**Amendment to ECE/TRANS/WP.29/GRSG/2014/27
 (Regulation No. 110, CNG/LNG vehicles)**

Proposal for amendments to Regulation No. 110 (CNG/LNG vehicles)

Submitted by the experts from the NGV Global.

Modify Figure 1-1 to add a new ‘Class 6’

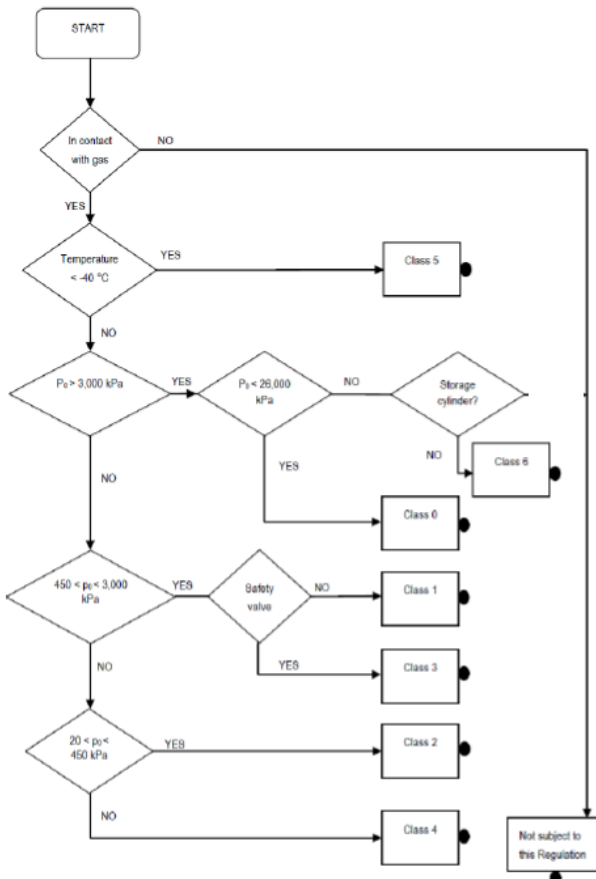
The text reproduced below was prepared by the experts from NGV Global to clarify the provisions of paragraph 18 following to include the ‘CNG accumulator’ and correct Figure 1-1 to improve clarity relative to the new Class 6.

1. In response to the GRSG discussion of Document ECE-TRANS-WP29-GRSG-2014-27e and a question posed by the French delegation to clarify Figure 1-1 and remove ‘Yes’ option from the ‘storage cylinder?’ decision box.
 2. The component ‘accumulator’ is not included in the list of components or definitions and is added here to fill that void.
-
